Official Transcript of Proceedings
NUCLEAR REGULATORY COMMISSION

Title: Advisory Committee on Reactor Safeguards
 NuScale Subcommittee

Date: Thursday, May 16, 2019

NuSCALE SUBCOMMITTEE

Open Item 03.09.02-4

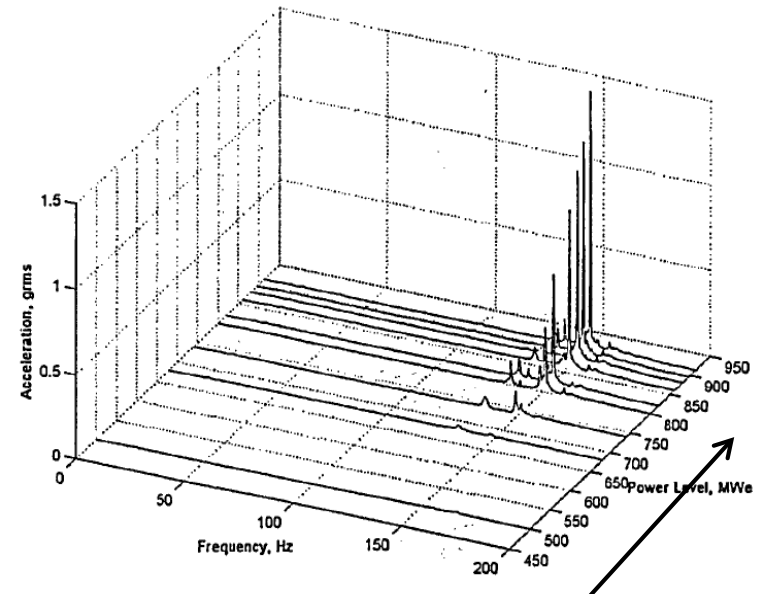
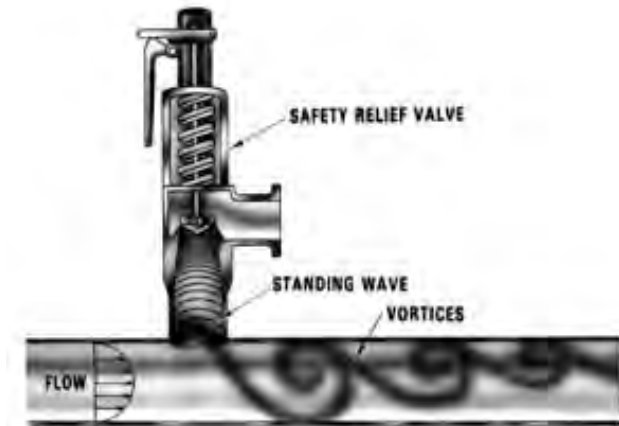
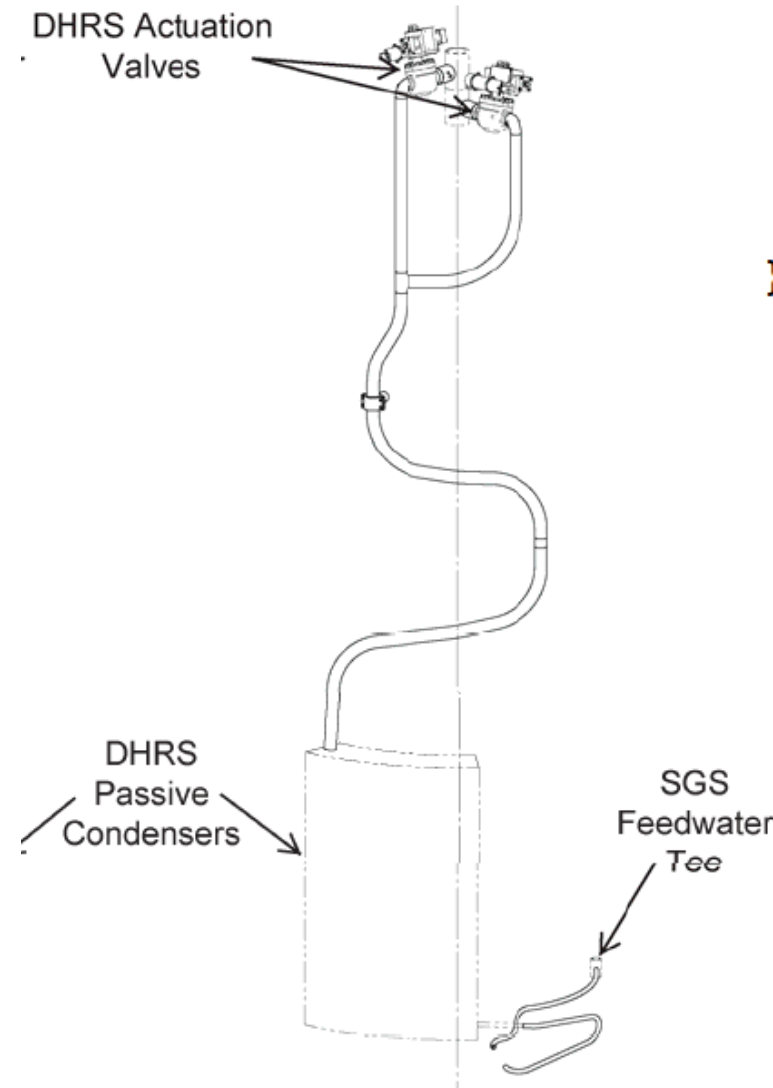
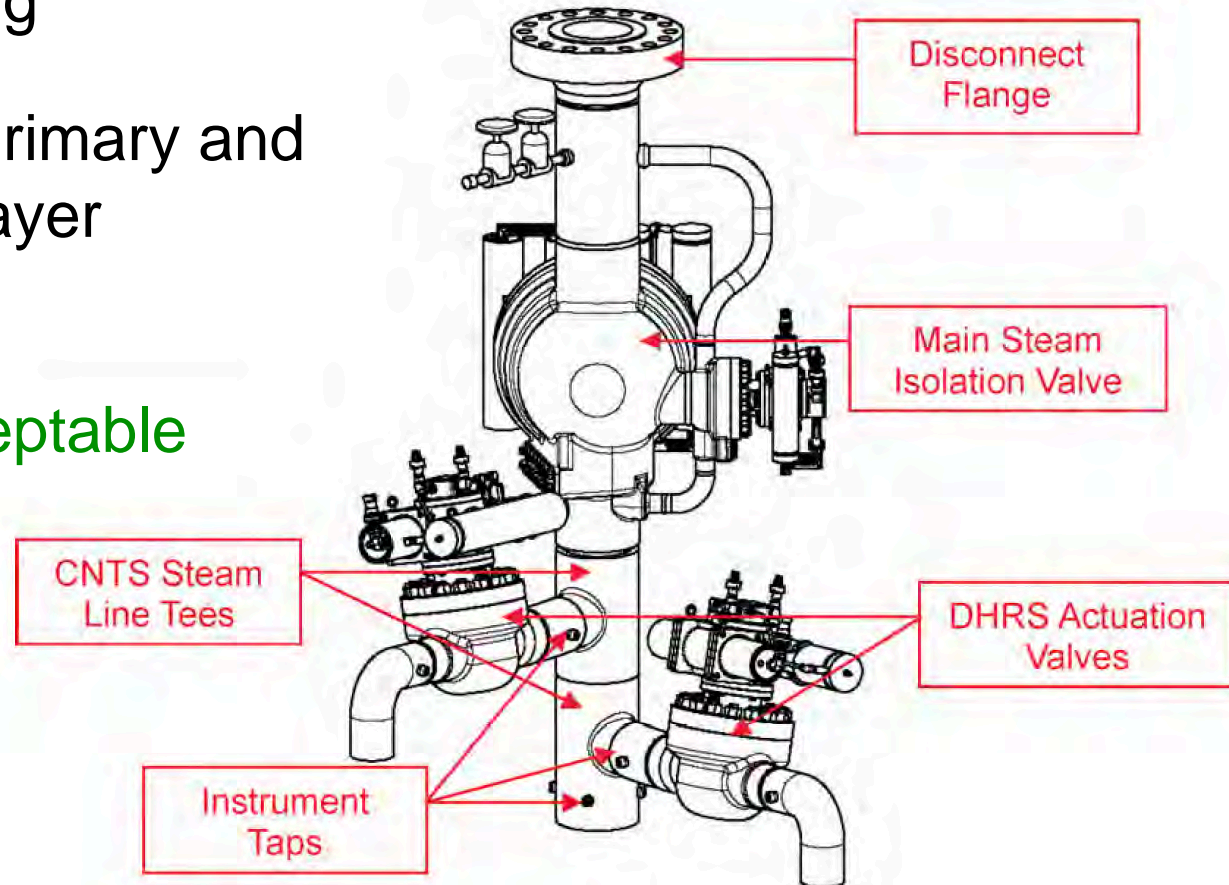
- Per test data in open literature, AR is possible if $0.35 < fD/U < 0.62$
 - f is the acoustic cavity resonance frequencies
 - D is the cavity diameter
 - U is the flow rate

- Two possible AR locations:
 - Closed side branch from containment system steam tee to the DHRS actuation valve
 - $fD/U=0.75$, ~ 20% margin
 - DHRS condensate line from SG system feedwater tee to DHRS passive condenser
 - $fD/U=1.33$, high margin against primary instability

- Proposed instrumentation for initial startup testing
- Will monitor both primary and secondary shear layer instabilities
- **RAI response acceptable**

Open Items 03.09.02-05 and 03.09.02-06

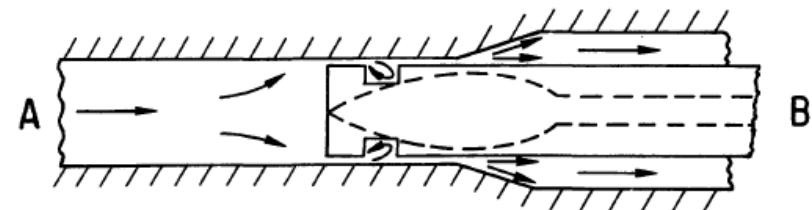
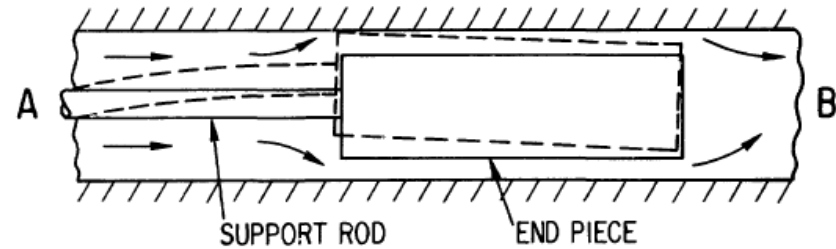
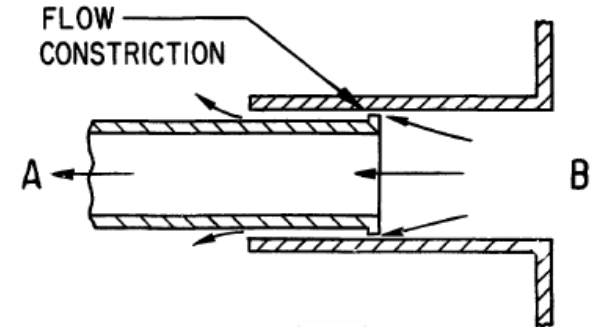
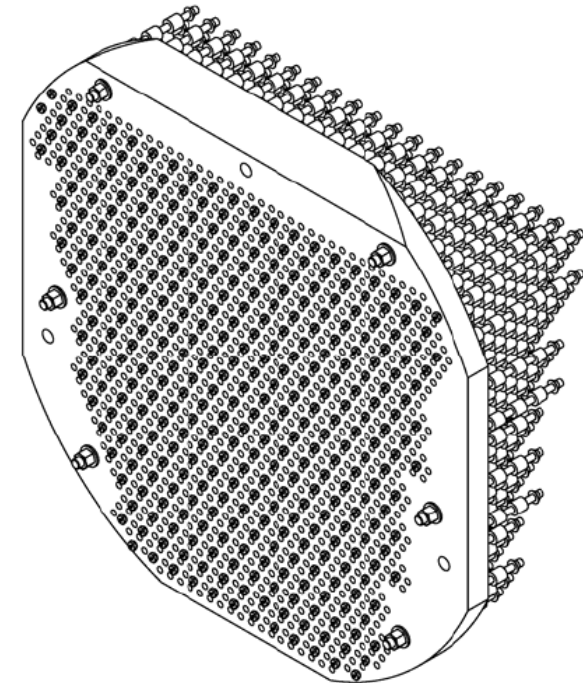
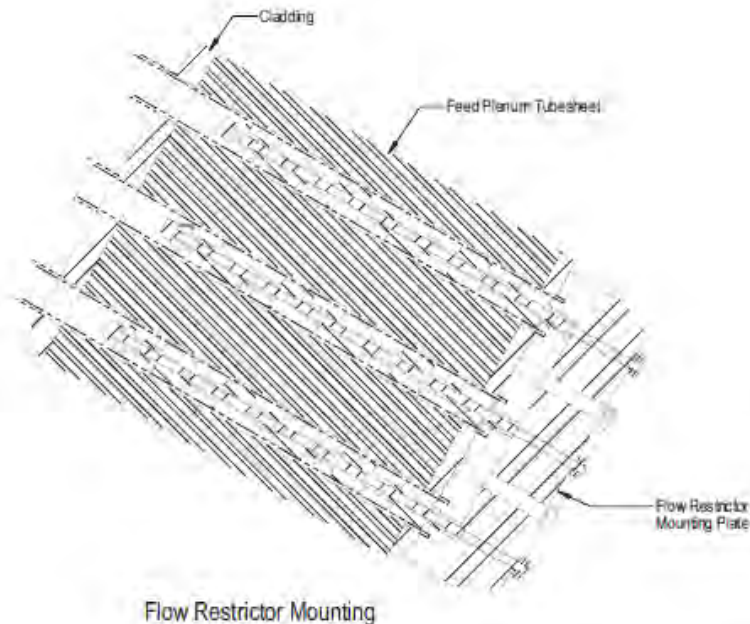
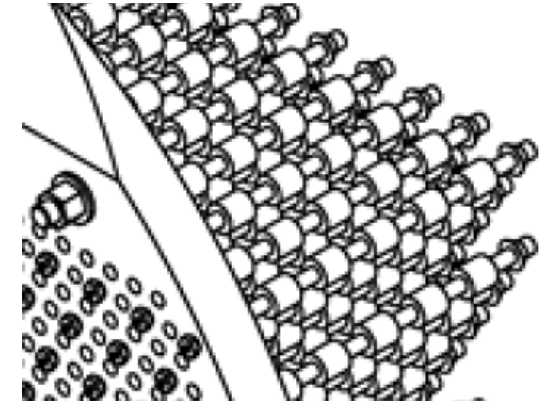
- Occurs in:
 - Narrow gaps between components with significant pressure drops
 - Control rods in guide tubes
 - Inlet flow restrictors

- Guidance from ANL report (Mulcahy, ANL-83-43)
 - Qualitative: obstructions should be downstream
 - Quantitative: every situation unique, requires measurements to assess risk

- Individual flow restrictors will be placed within each SG tube inlet
 - Purpose: mitigate another instability: Density Wave Oscillation (DWO) within SG tubes
- No analysis of LFI mechanisms
- However, multiple designs tested by NuScale

- Design least susceptible to LFI chosen
 - Test results show no sign of LFI or any other significant FIV
 - Minor changes made to final design
- Design Validation testing planned prior to initial startup in separate facility
 - Test plan provided in MIP, reviewed by staff and found to be reasonable
 - Lessons learned from design tests will be applied to validation testing
 - Report with results will be issued to the NRC after Design Certification – May impose license condition or COL item
